Subject: Proposed Change No. 7 to Appendix A,
DPR-25, AEC Dkt 50-249

DRESDEN STATION UNIT 2/3

CHIMNEY SAMPLE LINE PLATEOUT TEST

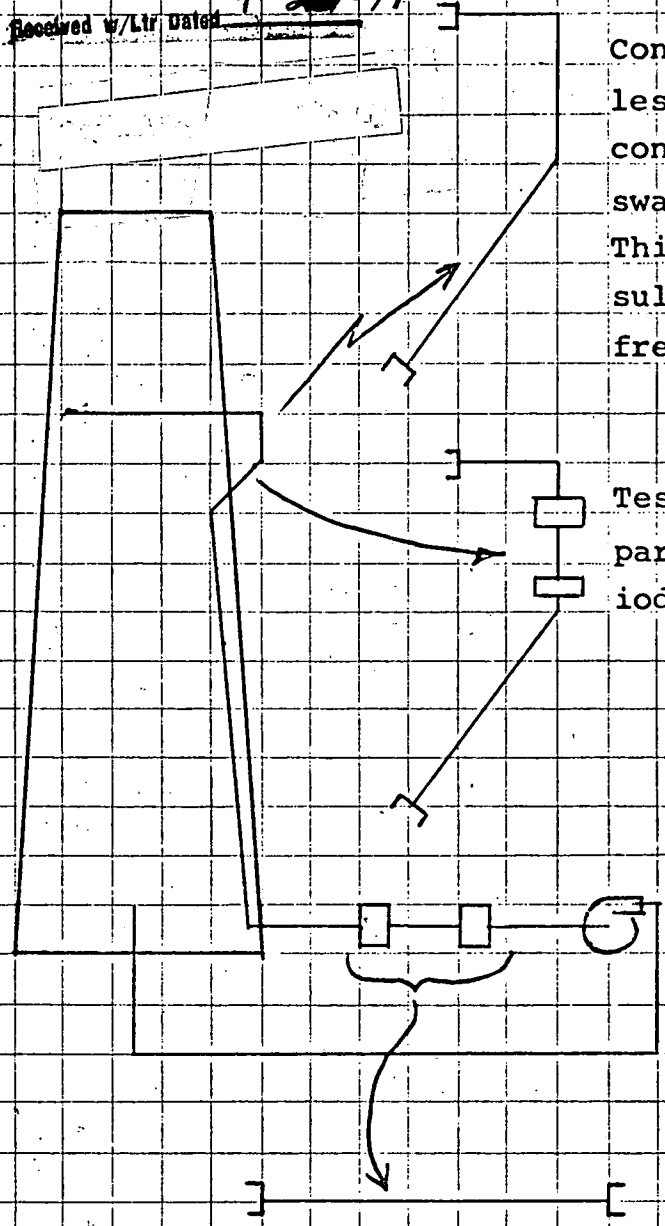
To perform the chimney sample line plateout test, it is necessary to install a test section, with a particulate and iodine filter, as near as possible to the inlet of the sample probe which is at the 200' elevation of the chimney (see attached sketch). The test program is summarized below.

Continuous stainless steel tubing, connected with swagelock fittings. This tubing is insulated to prevent freezing.

Test section, with particulate and iodine filter.

Test section to be installed when iodine and particulate filters are installed at isokinetic probe.
